ORIGINATION FORM

Proposed Revisions to a Standard Plans Index
(Please provide all information — Incomplete forms will be returned)

Index Number: 700-041
Sheet Number (s): 2 of 5
Index Title: Span Sign Structure

BASE PLATE CONNECTION

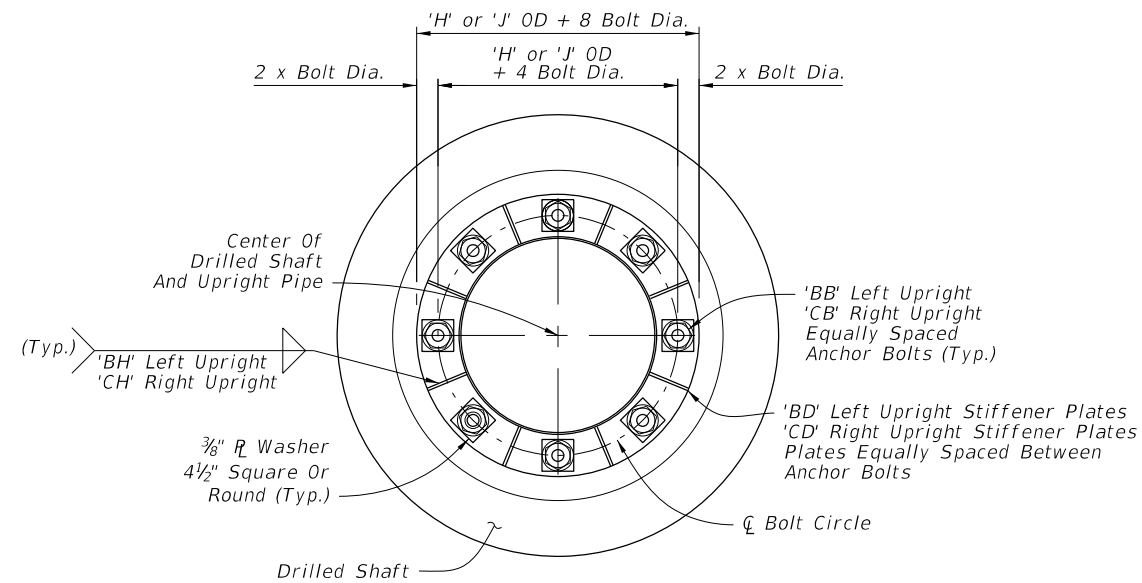
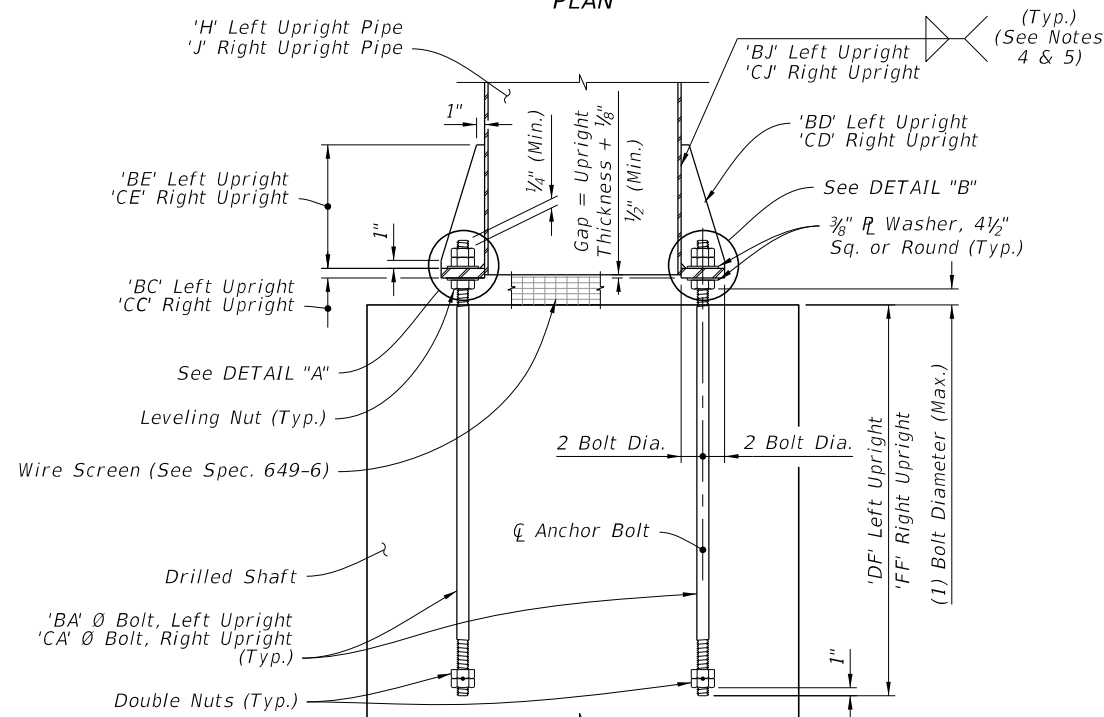
Revised Note 5 to read "After galvanizing, provide magnetic particle testing on 100% of upright fillet welds."

During maintenance inspections, weld cracks were found on in-service overhead sign structure supports. A FDOT investigation determined the cracks were formed during fabrication. To implement a better fabrication quality control processes, the note on the Standard is being changed.

1. See Traffic Plans for elevation at top of Foundation.
2. Install Drilled Shaft with a 2'-0" minimum from top elevation of the drill shaft to the finished grade, unless specified otherwise in the plans.
3. The shaft length is based on 2'-0" height above finished grade.
4. Wrap fillet weld around the stiffener termination on the tube wall (Typ.).
5. ~~Provide ultrasonic testing for Lamellar Tearing when wall thickness exceeds 1/2"~~

After galvanizing, provide magnetic particle testing on 100% of upright fillet welds.
